Huggens College, College Road, Northfleet - GB/20240402

RE: KENT HIGHWAYS CONSULTEE COMMENTS

ADDITIONAL INFORMATION REQUEST

Application - GB/20240402

Scale 1:250 @ A3		SLR Project No.	
Designed AA	Drawn AA	Checked TF	Authorised AT
Date 12.07.24	Date 12.07.24	Date 12.07.24	Date 12.07.24
Drawing Number 418.063079.00001-PD01			Rev. -

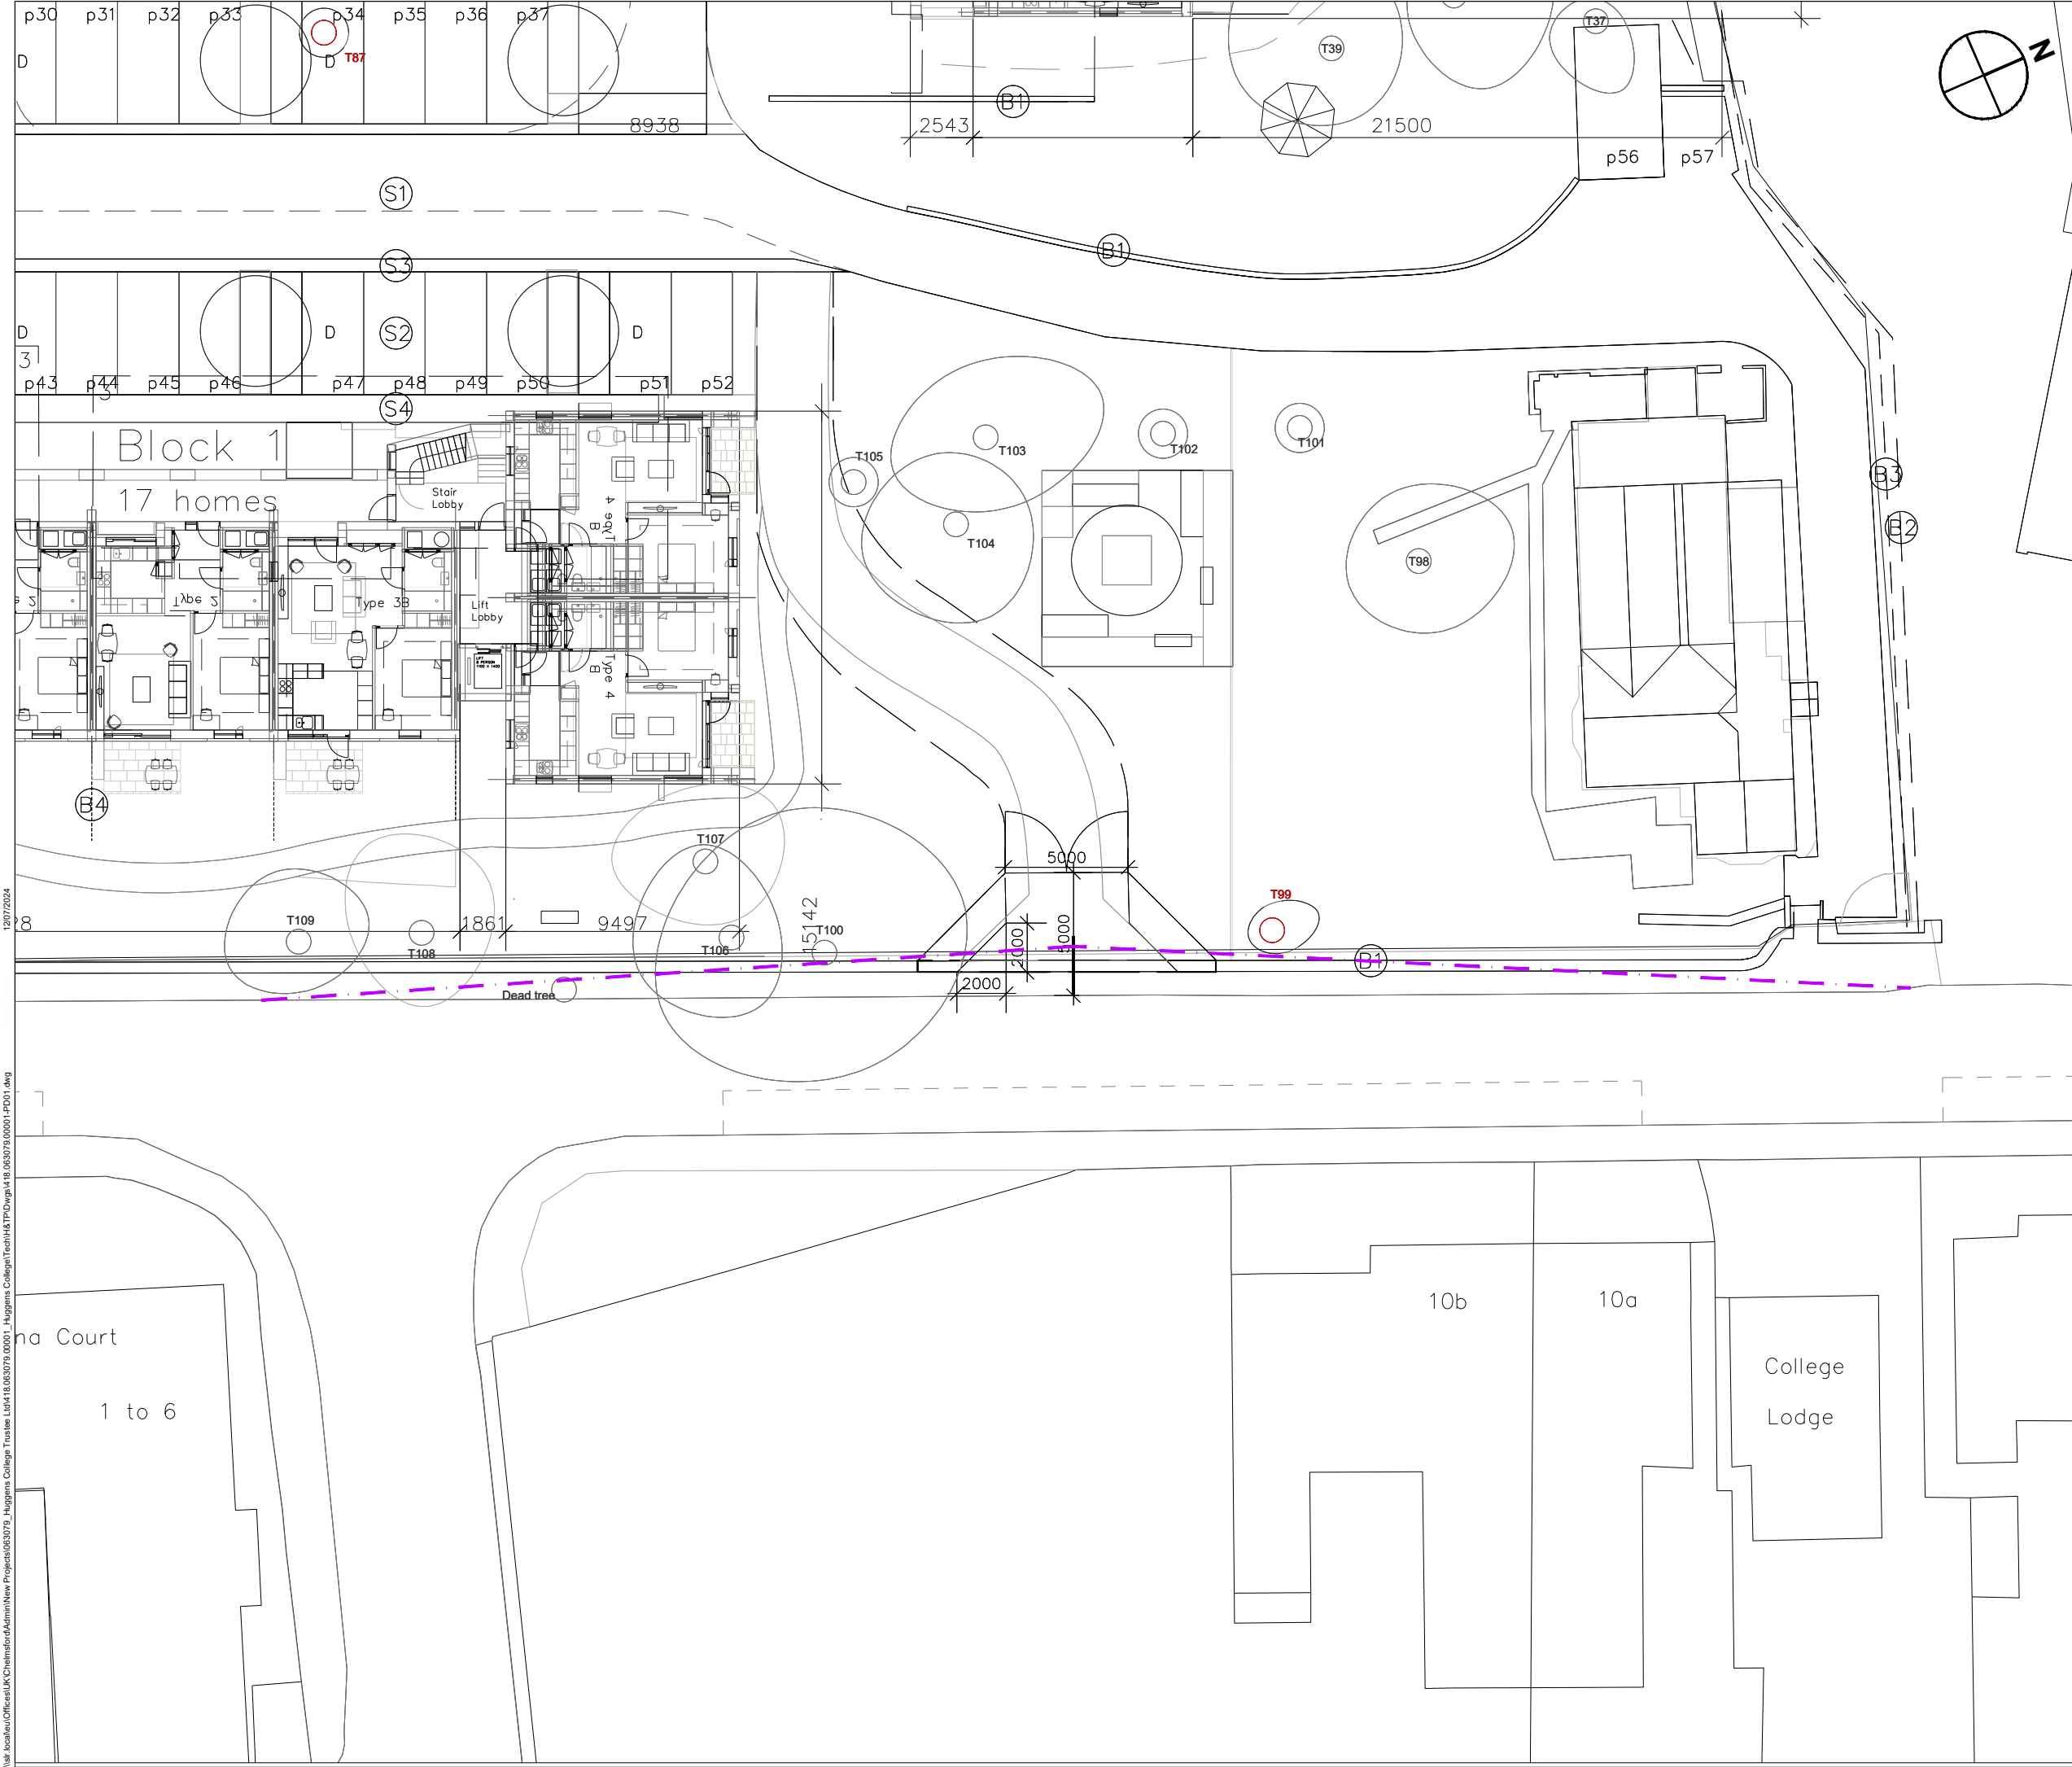
Drawing H005-C R1 shows 22m vehicle visibility splays for the temporary access and 2m x 2m pedestrian visibility splays for the subsequent emergency access. The 'Y' distance of 22m shown on the plan equates to a speed of approx. 20mph. However, table 4-3 shows the 85th percentile speeds recorded by the ATC were 25mph northbound and 26mph southbound.

Based on table 7.1 of Manual for Streets, this equates to splays of 33m and 34m (respectively). The plan should be updated to reflect this.

A junction visibility plan for the existing access is attached at **Appendix D** which shows that 33m and 34m visibility splays are achievable from a 2m setback from the edge of the carriageway. Whilst this is a step below the recommended 2.4m 'X' distance, the access is temporary for the construction phase, then reverting to a secured emergency access only. During any construction vehicle activity at the temporary site access there will be trained banks-people to manage arrivals and departures. To provide the 2.4m 'X' distance a significant increase in the length of original wall removal would be required.

Scale 1:500	@ A3	SLR Project No.	
Designed AA	Drawn AA	Checked TF	Authorised AT
Date 12.07.24	Date 12.07.24	Date 12.07.24	Date 12.07.24
Drawing Number 418.063079.00001-AT01	Rev. A

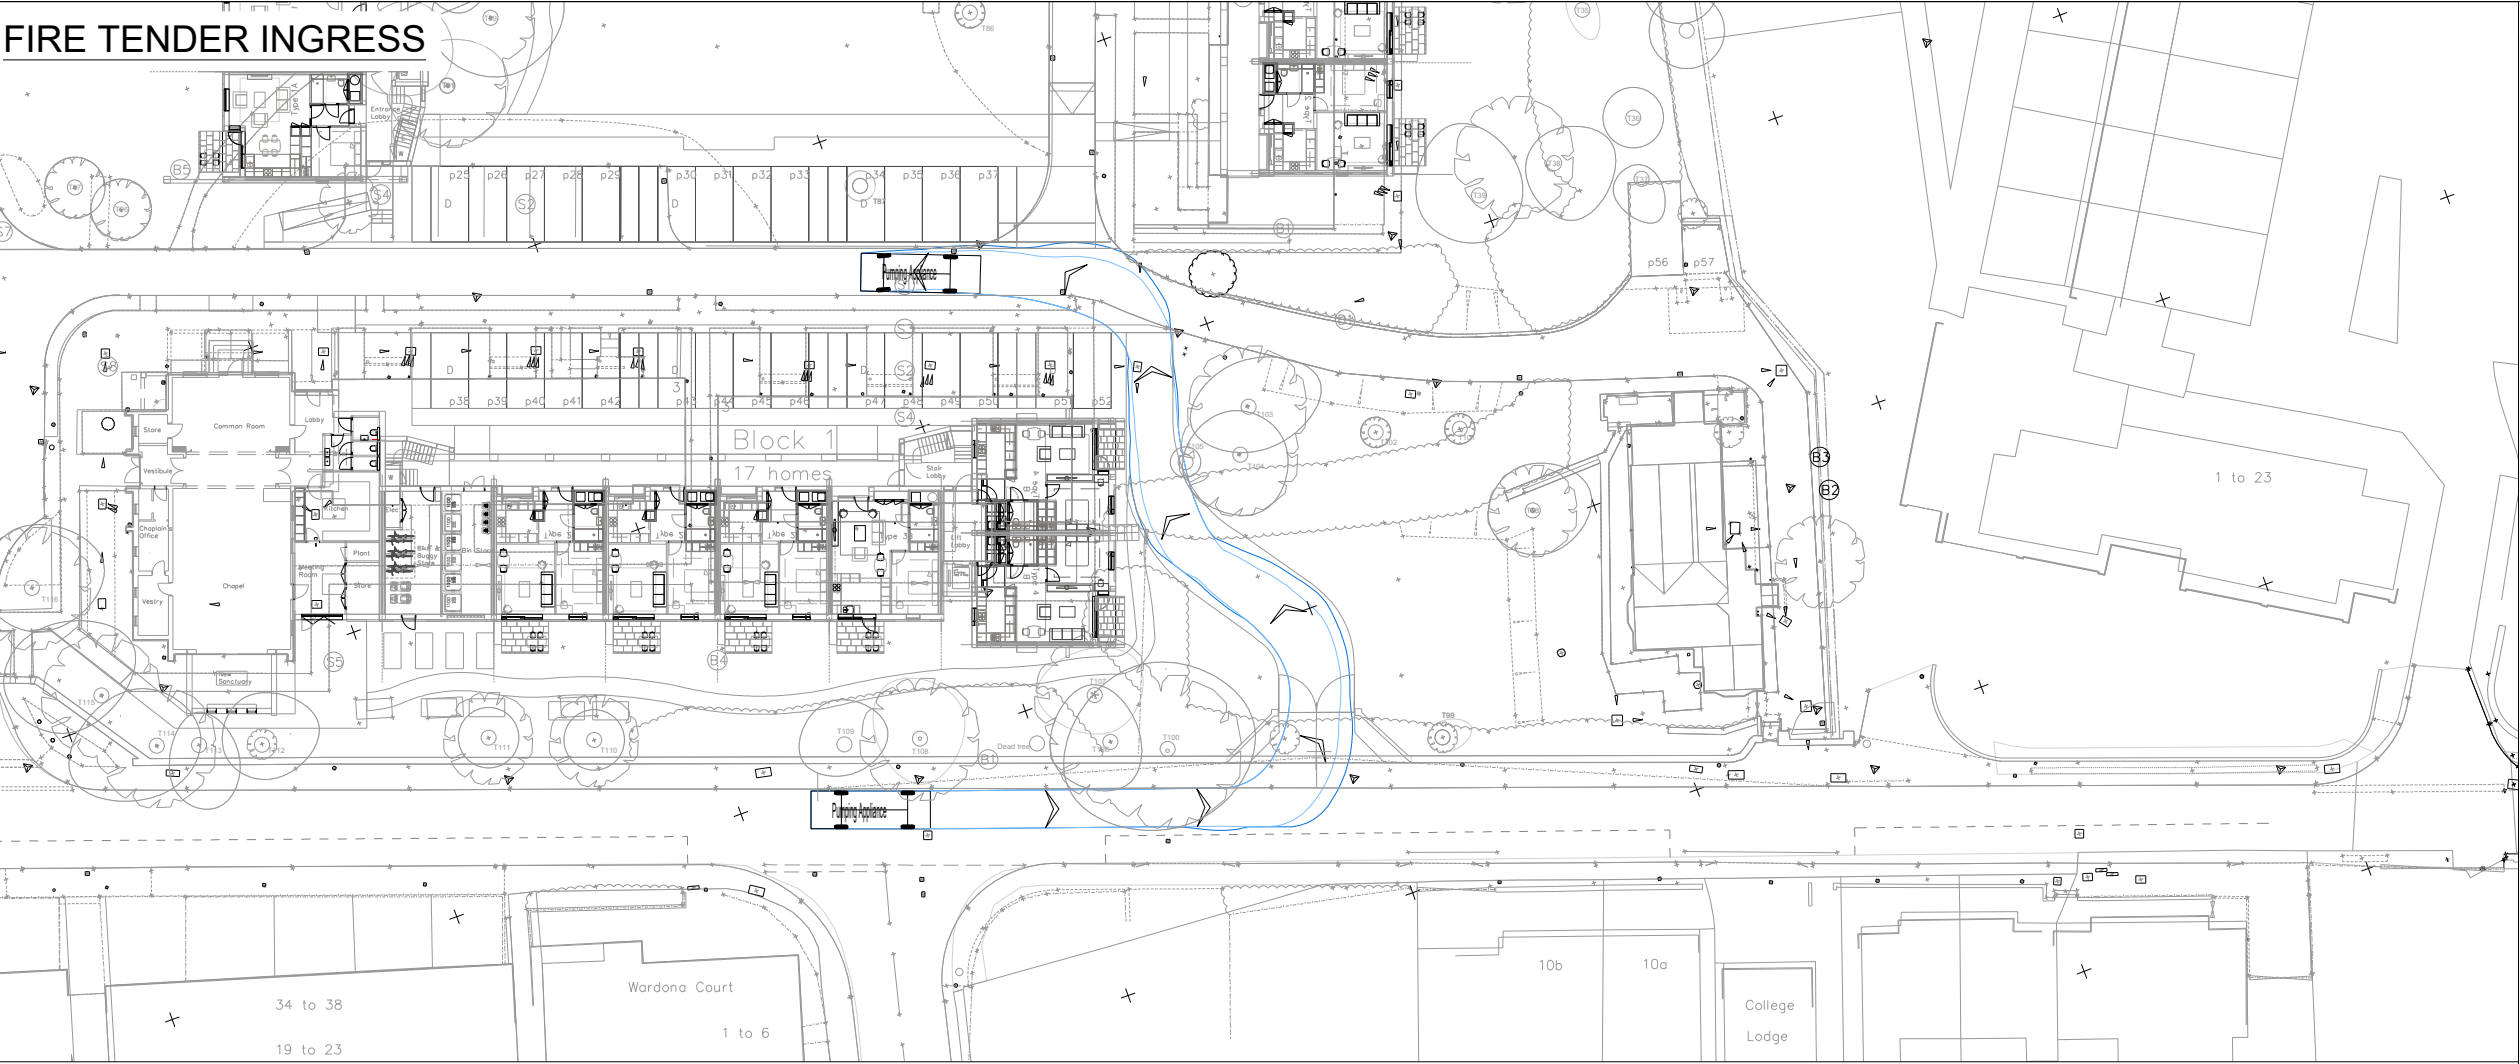
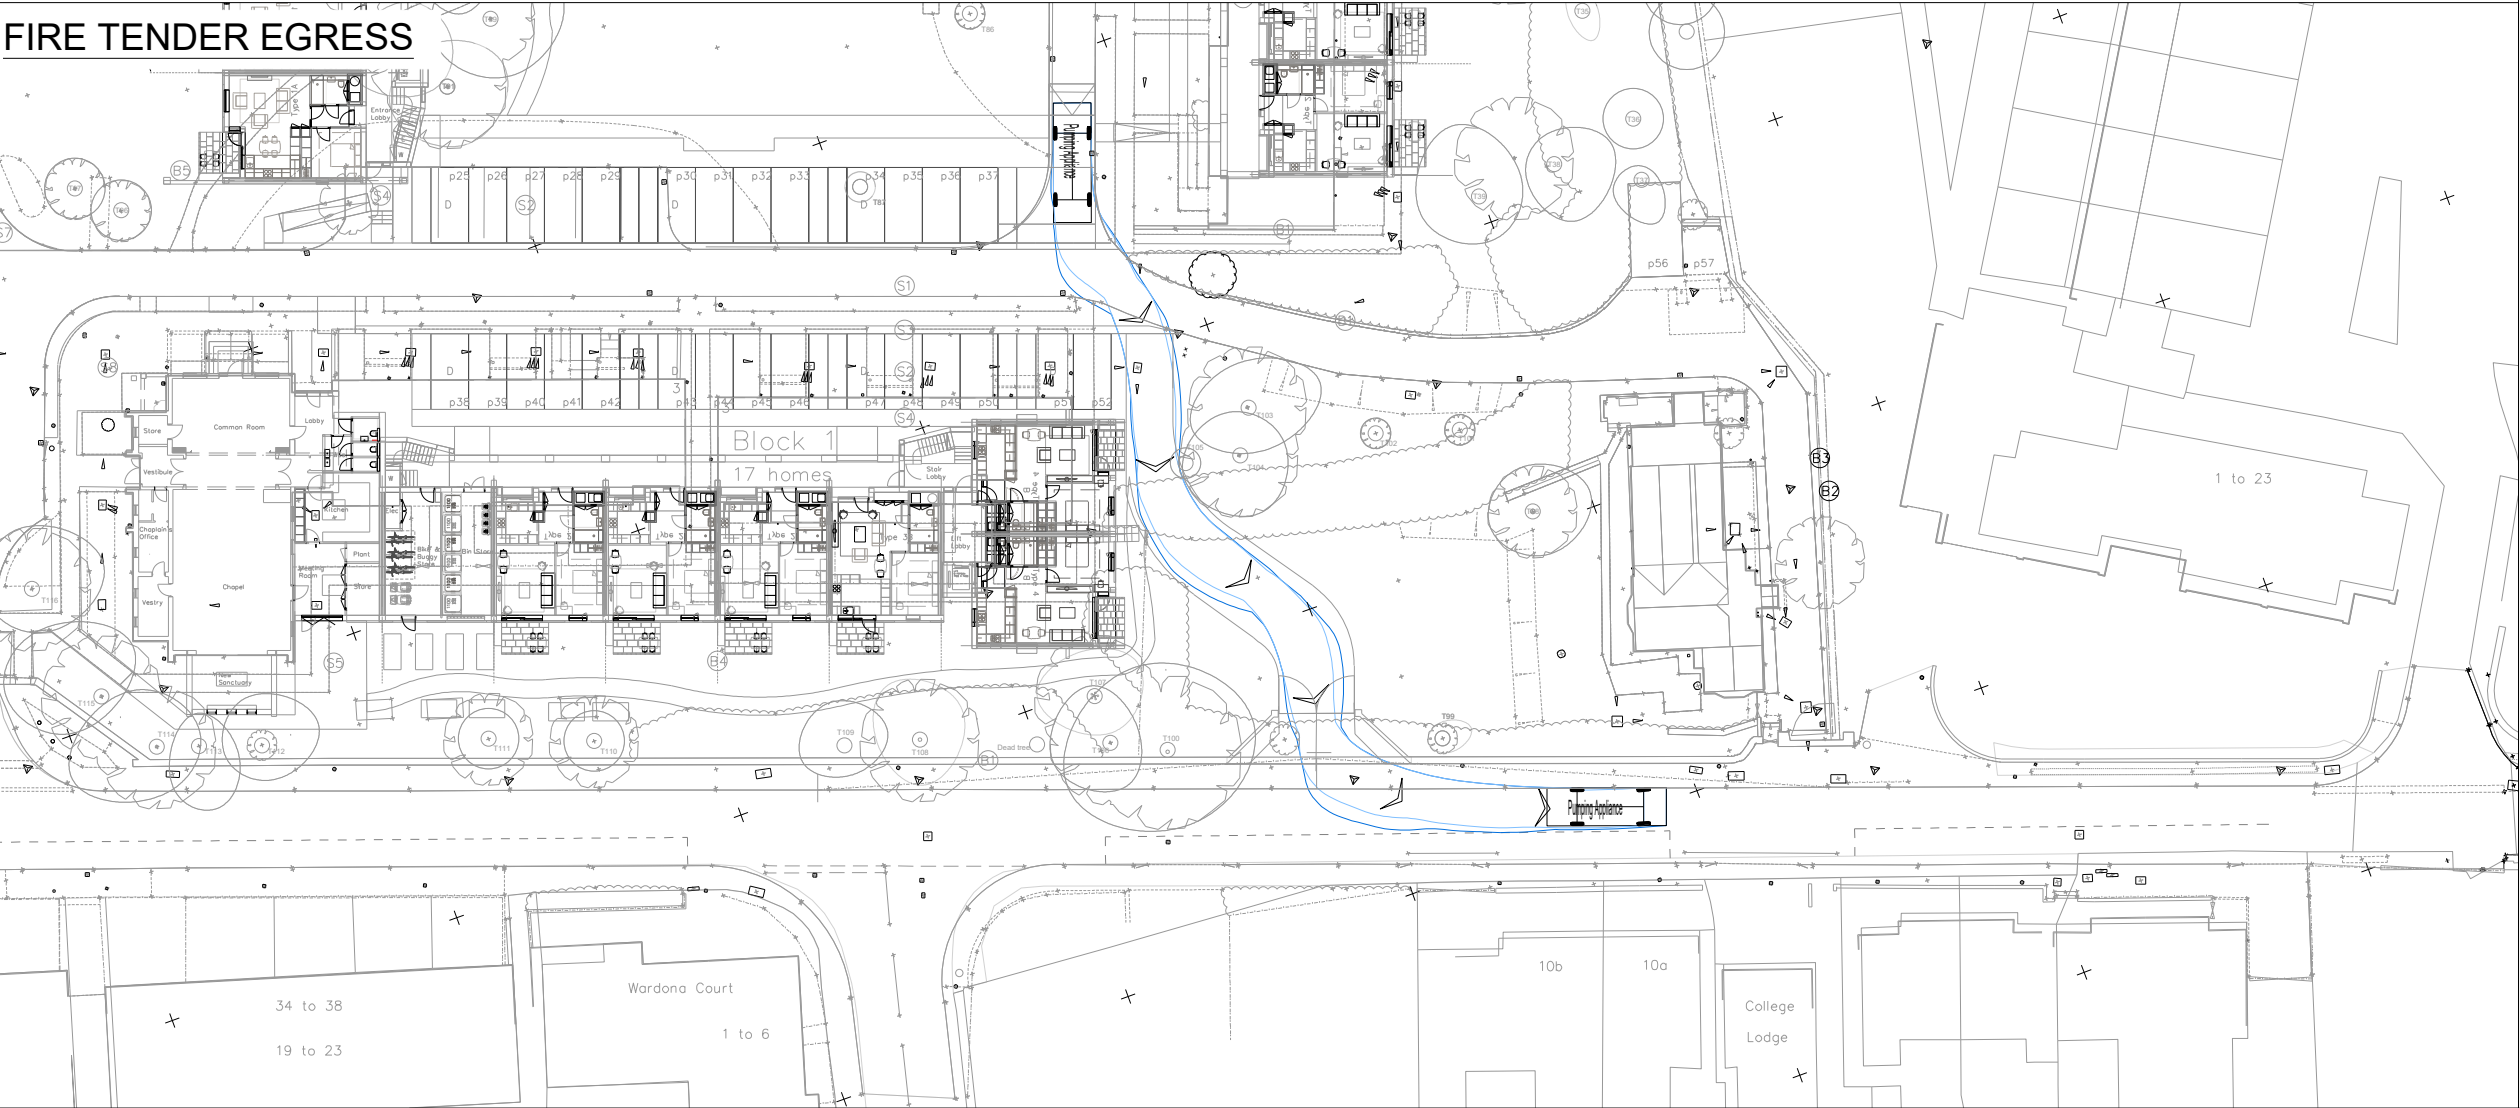
Tracking of a refuse vehicle has been provided and is acceptable. However, no tracking has been provided for the temporary access. Tracking of a fire appliance vehicle is required. Alternatively, if this access is to be used for construction, tracking for the largest construction vehicle likely to access the site, could also be shown (if not, this will be requested for the Construction Management Plan).

A swept-path analysis is attached at **Appendix E** which shows a fire tender can access and egress in a forward gear. Additionally, the swept-path analysis includes the turning requirements for a small tipper and skip lorry demonstrating that the secondary access could also be used for construction vehicles for development phasing purposes.
